Re: 2nd Technical Submission Review – The Overlook at Sorrel Ranch – Preliminary Plat and Final Plat

Application Number: **DA-1379-26**

Case Number: **2019-4017-00; 2019-3050-00**

OVERLOOK AT SORREL RANCH SITE PLAN WITH ADJUSTMENTS

associates inc.	2953 South Peoria Street, Ste 101 Aurora, Colorado 80014 303-770-7201 FAX 770-7132
SHEET NUMBER	L-1
PROJECT NO.	8173-000

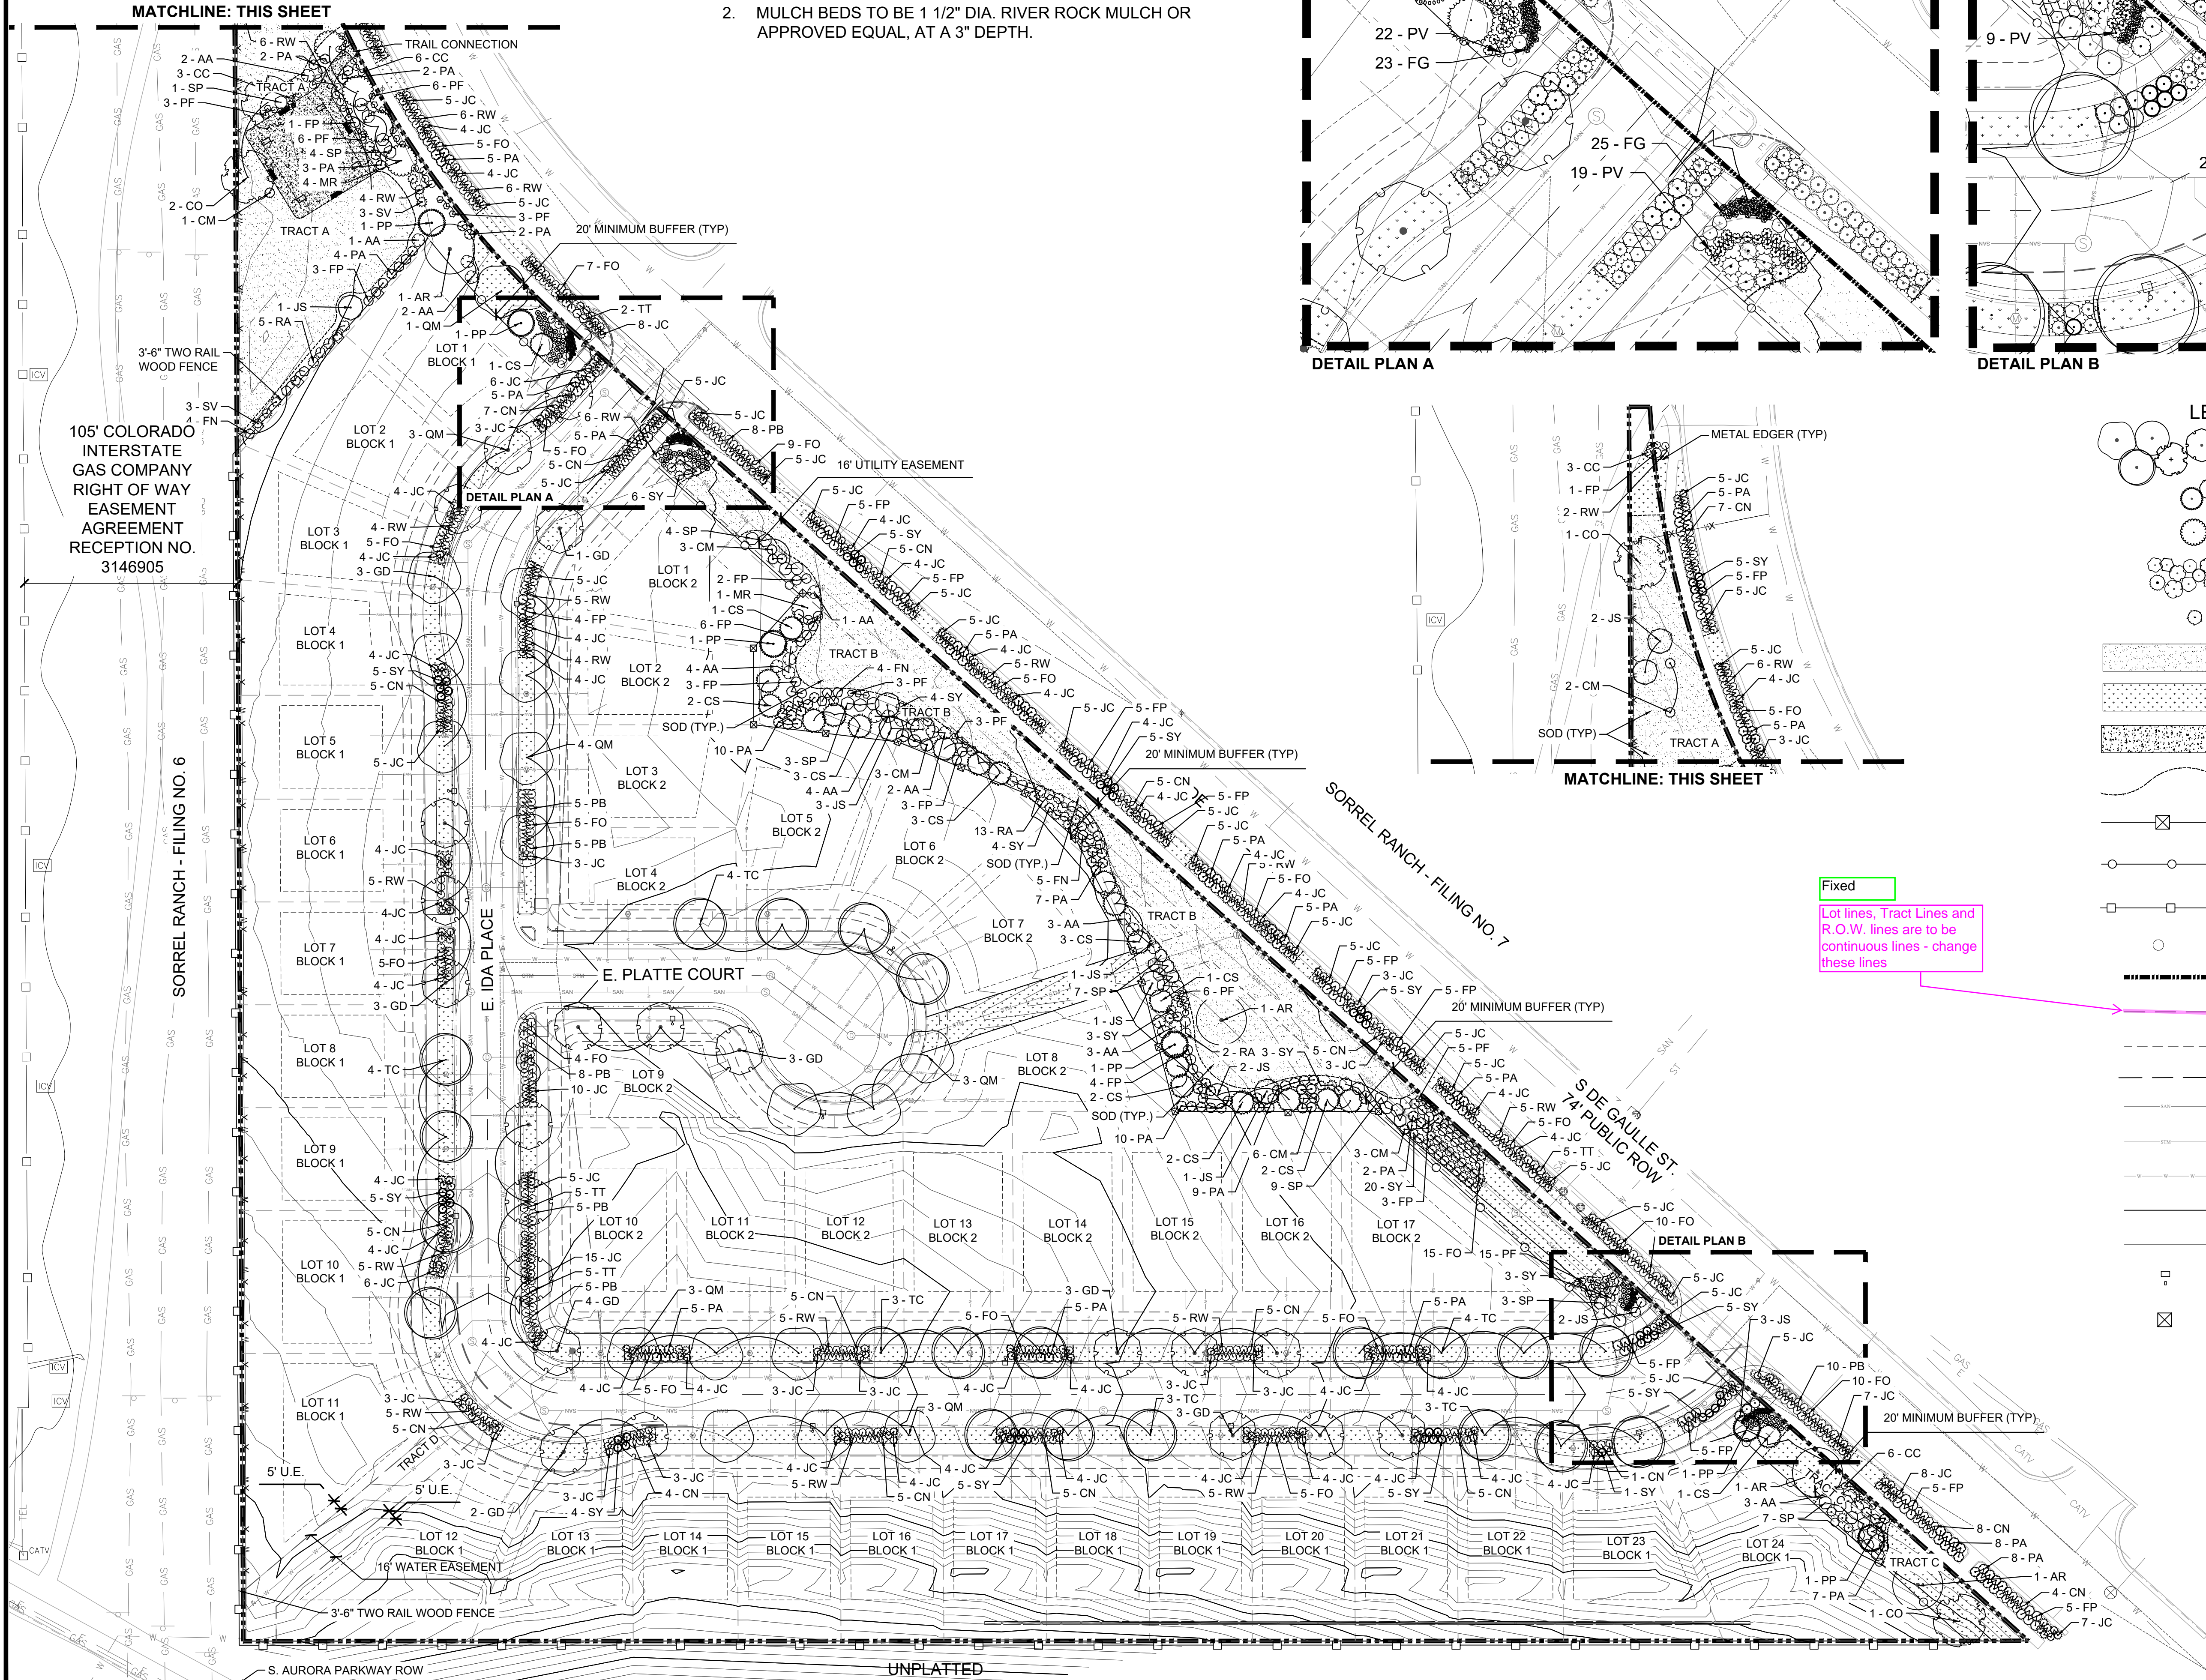
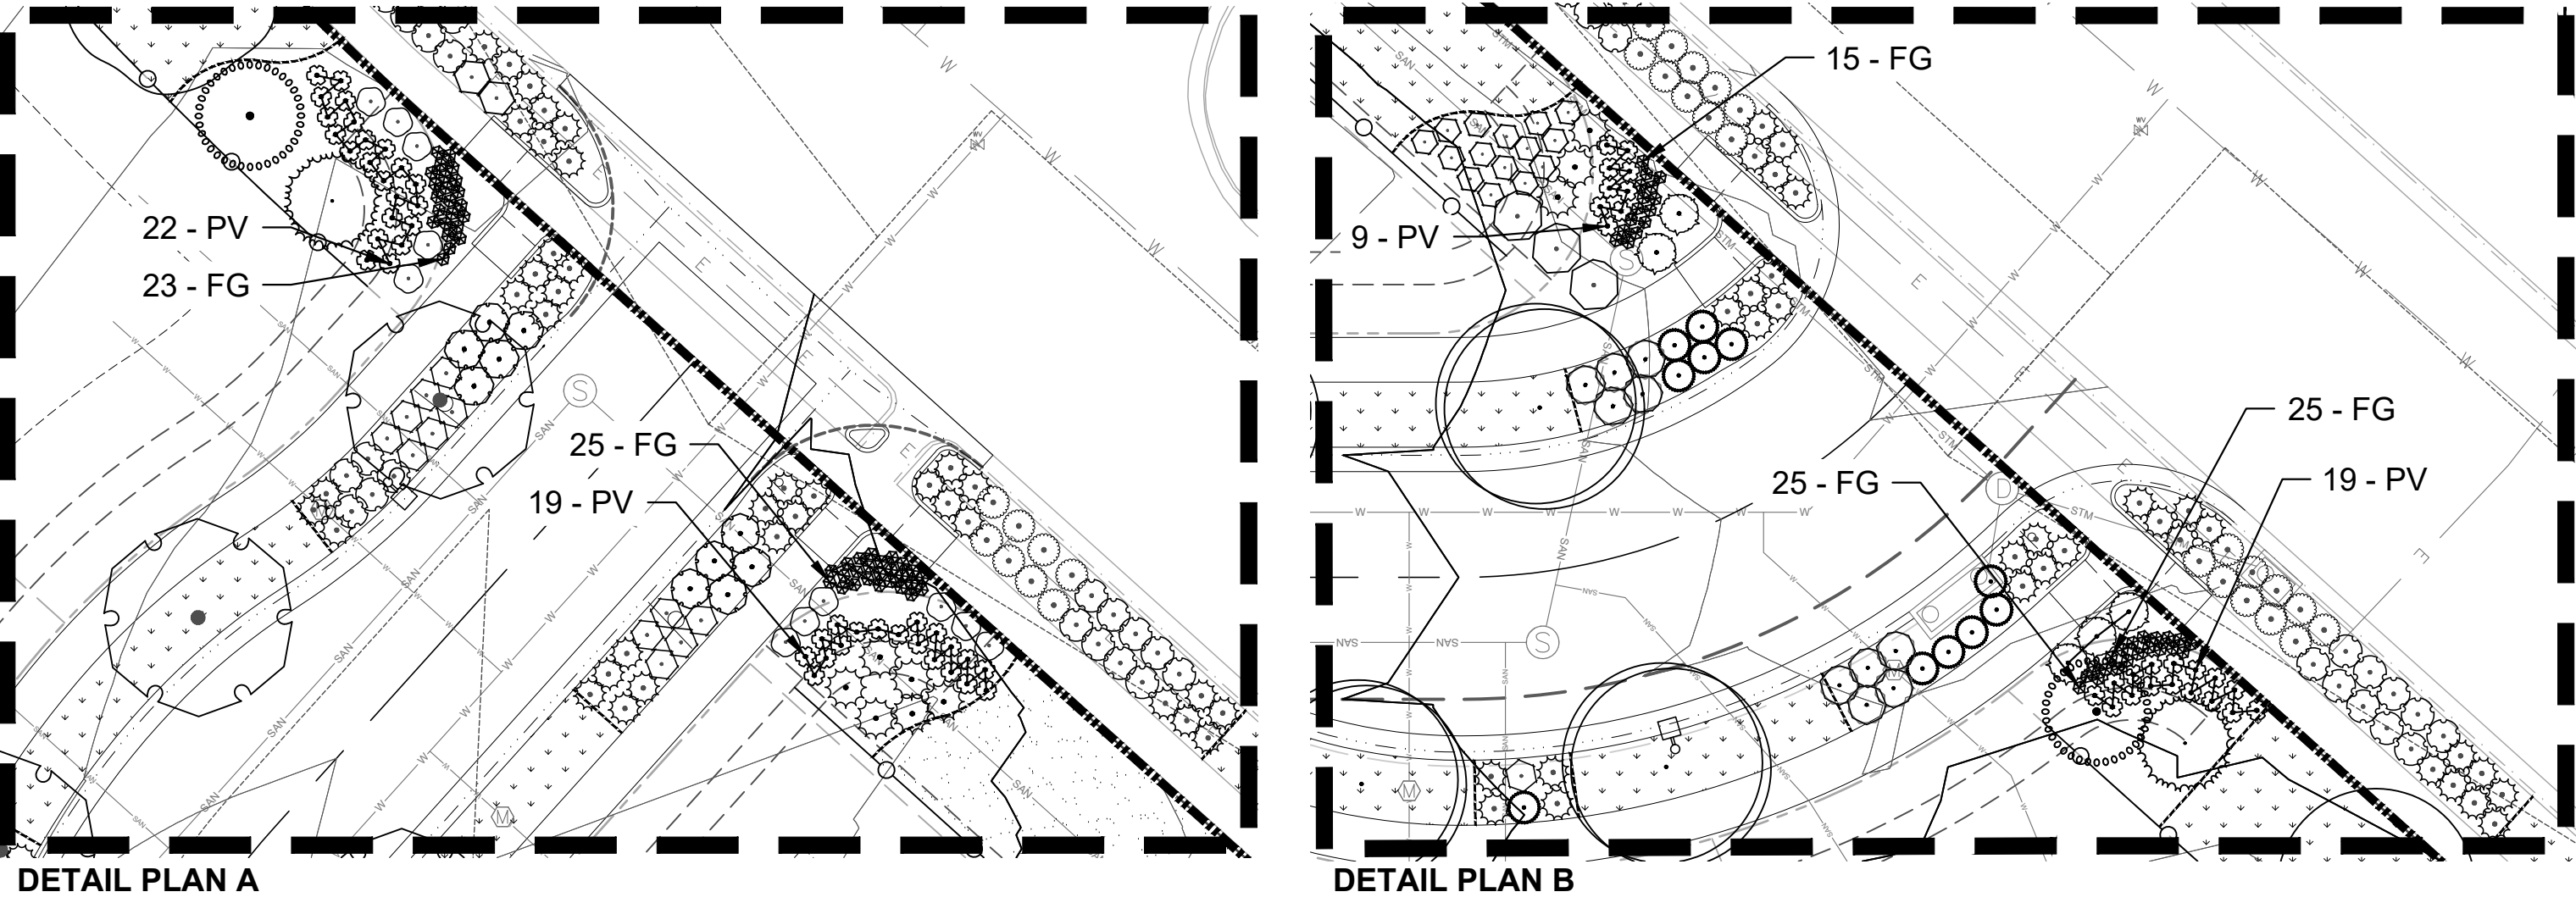
Fixed
Lot lines, Tract Lines and R.O.W. lines are to be continuous lines - change these lines

L-3

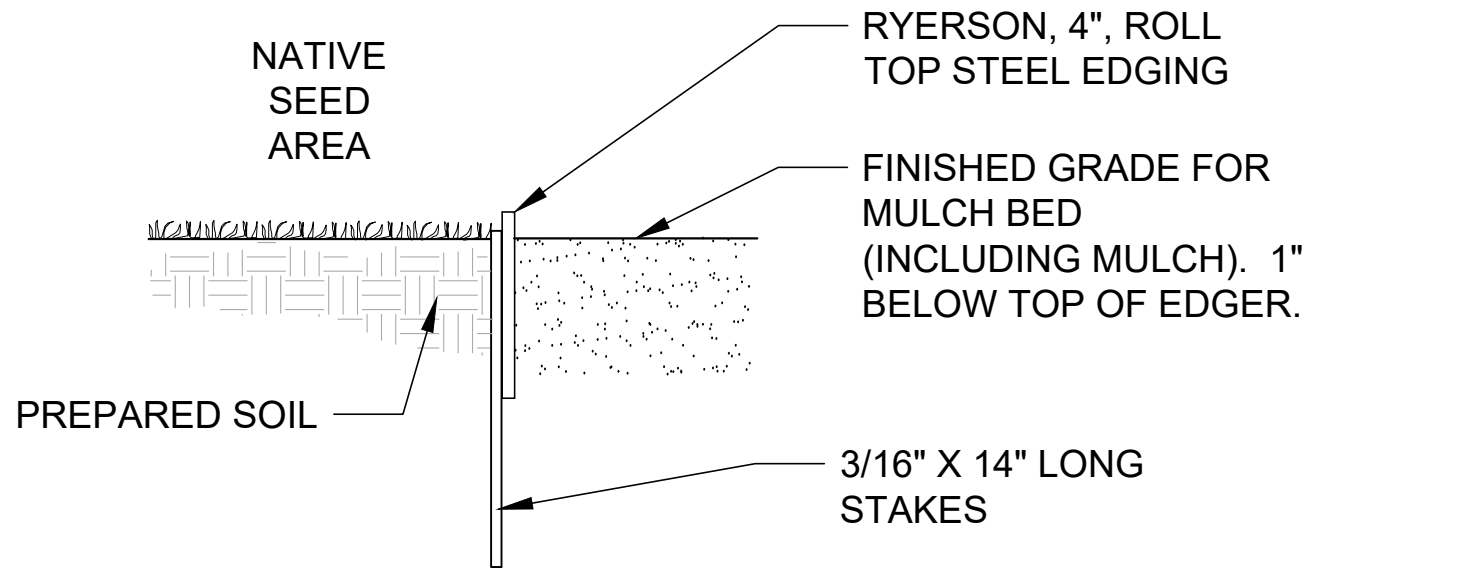
5A. Correct all highlighted printing errors highlighted on this sheet. *Printing errors fixed*.

Printing errors on this sheet. Please correct.

Printing errors on this sheet. Please correct.

Fixed

Fixed

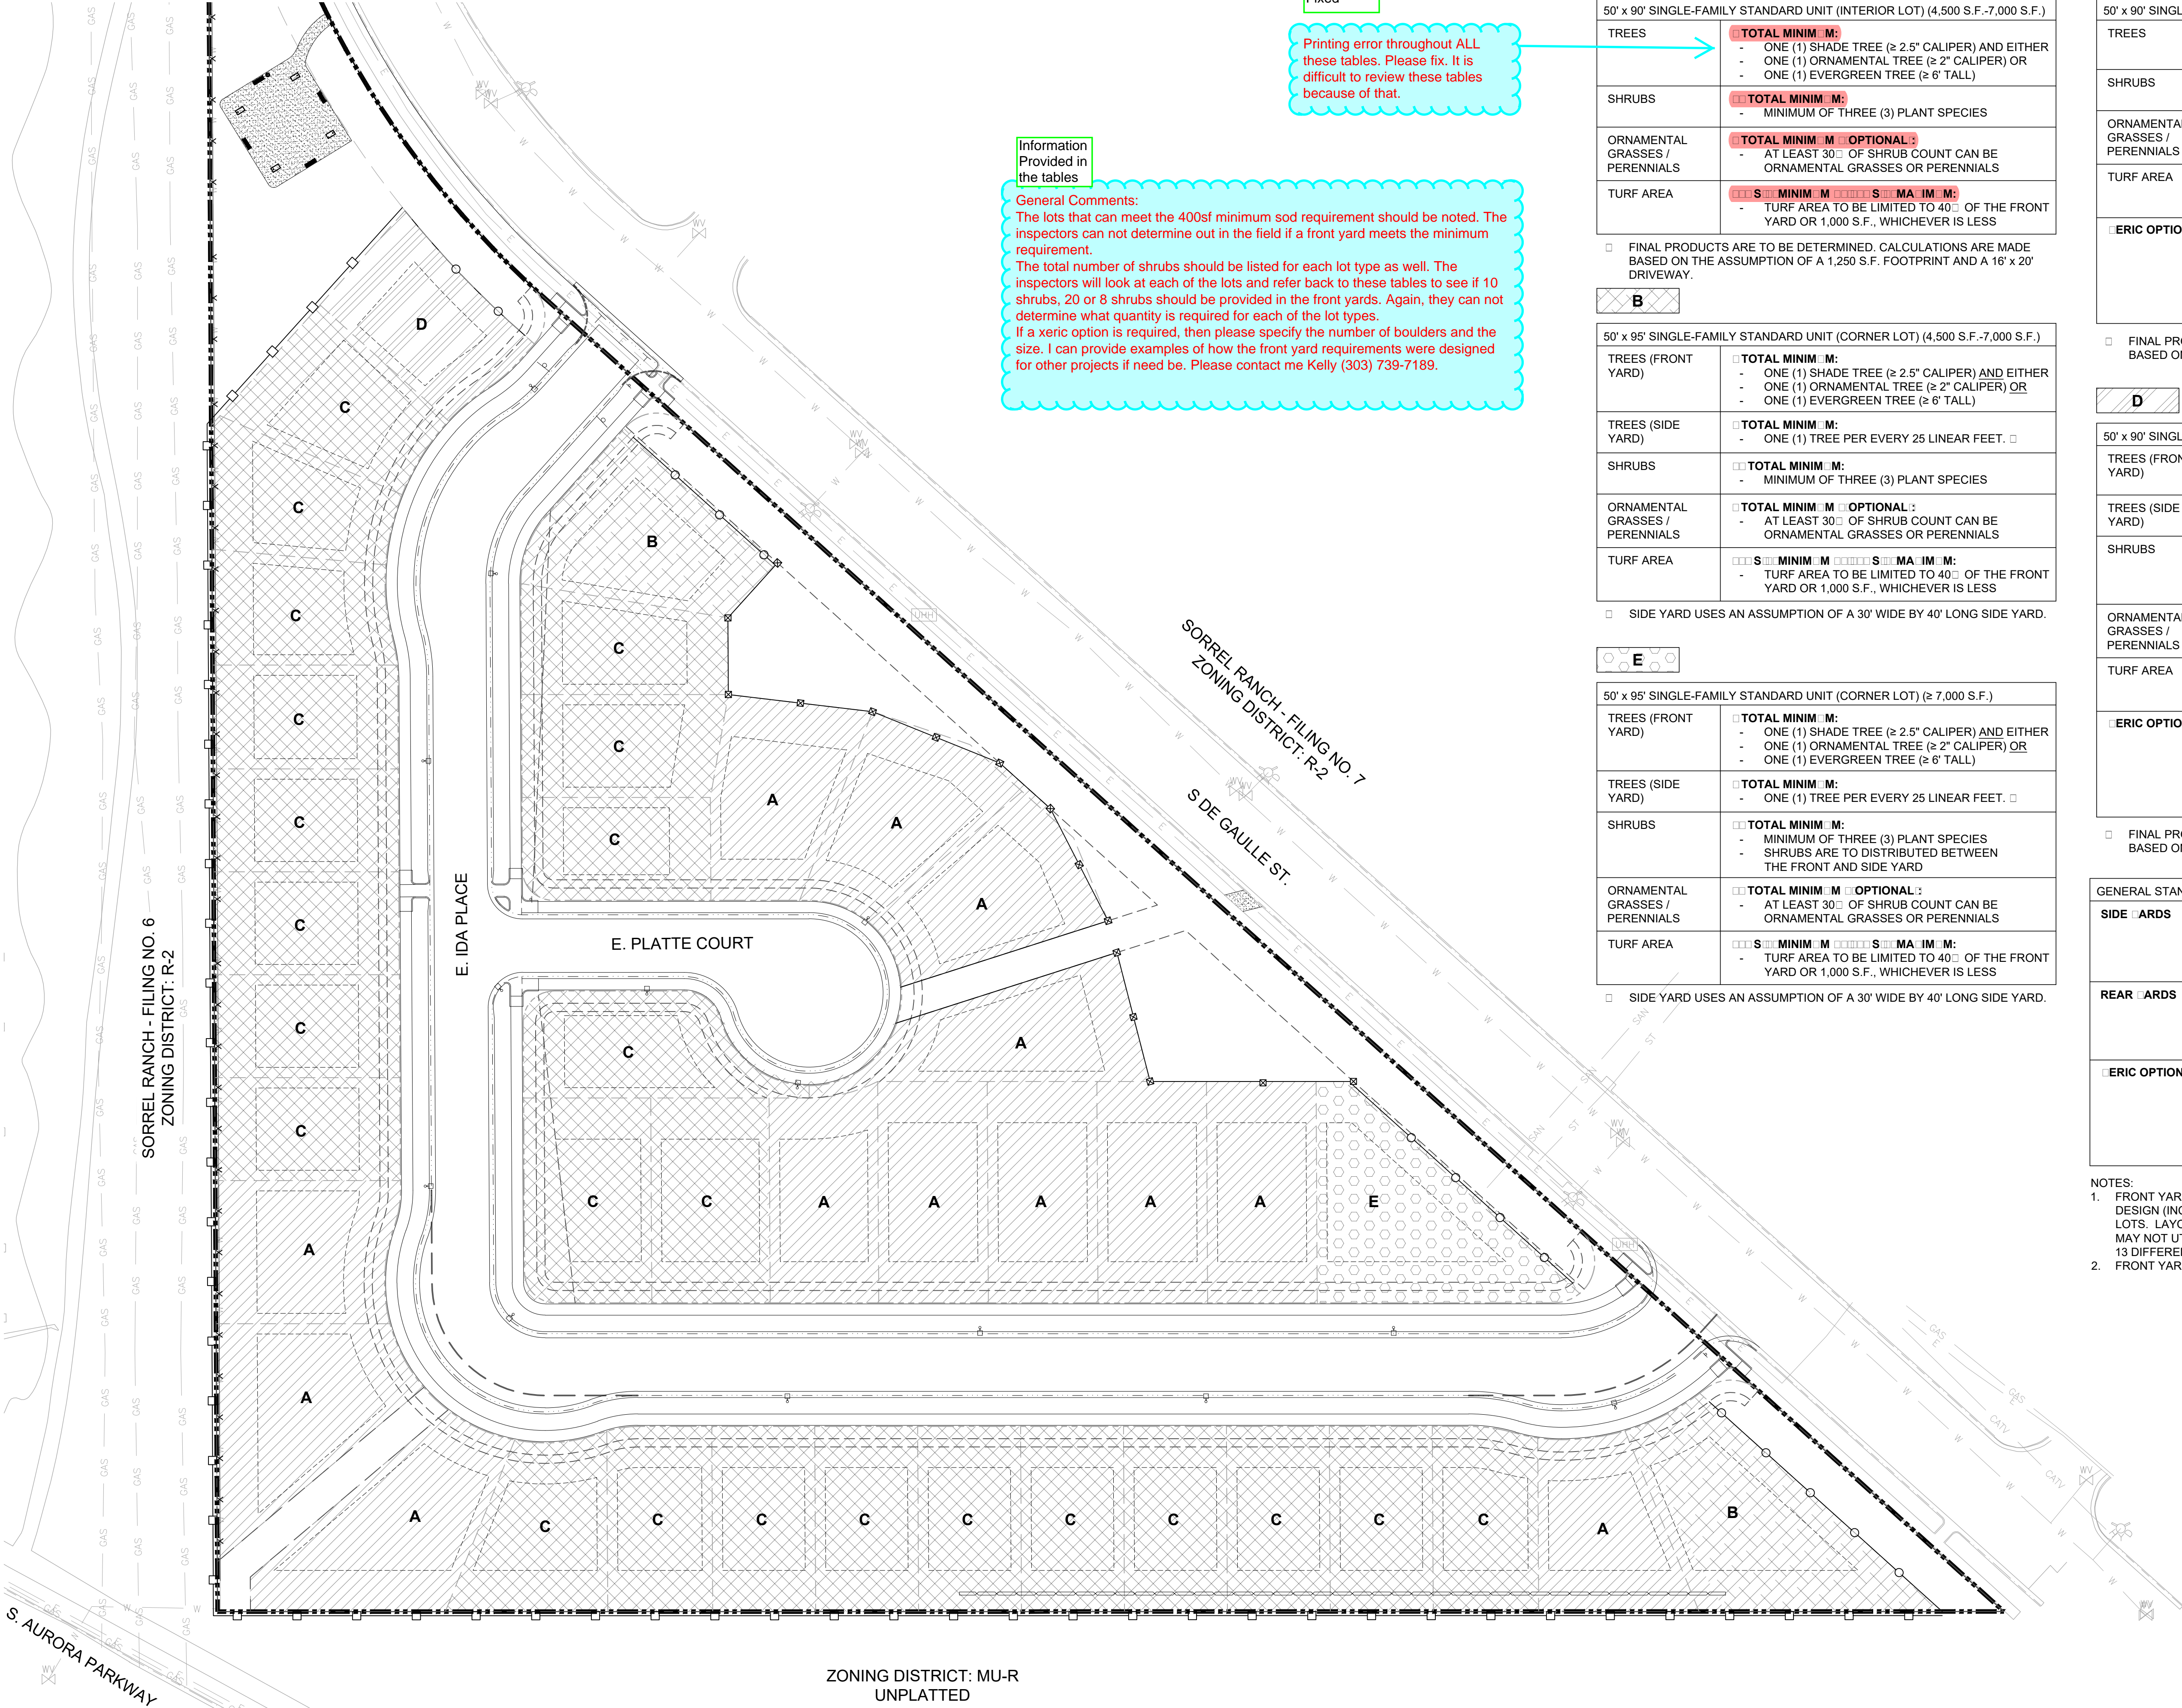
- The lots that can meet the 400sf minimum sod requirement should be noted. The inspectors cannot determine out in the field if a front yard meets the minimum requirement. *Lots noted in table.*

- The total number of shrubs should be listed for each lot type as well. The inspectors will look at each of the lots and refer back to these tables to see if 10 shrubs, 20 or 8 shrubs should be provided in the front yards. Again, they cannot determine what quantity is required for each of the lot types. *Quantities provided in table*

- If a xeric option is required, then please specify the number of boulders and the size. I can provide examples of how the front yard requirements were designed for other projects if need be. Please contact me Kelly (303) 739-7189. The tables and the plan on this sheet will be what the inspectors use for inspections and issuing certificates of occupancy. If the xeric option is required, as is the case with some of the options below, then the special landscape features (i.e. boulders, berming, fencing, etc.) should be included in the requirements under that lot type. *Xeric option not provided*

General Comments:
The lots that can meet the 400sf minimum sod requirement should be noted. The inspectors can not determine out in the field if a front yard meets the minimum requirement.
The total number of shrubs should be listed for each lot type as well. The inspectors will look at each of the lots and refer back to these tables to see if 10 shrubs, 20 or 8 shrubs should be provided in the front yards. Again, they can not determine what quantity is required for each of the lot types.
If a xeric option is required, then please specify the number of boulders and the size. I can provide examples of how the front yard requirements were designed for other projects if need be. Please contact me Kelly (303) 739-7189.

Printing error throughout ALL these tables. Please fix. It is difficult to review these tables because of that.

Information Provided in the tables

Fixed
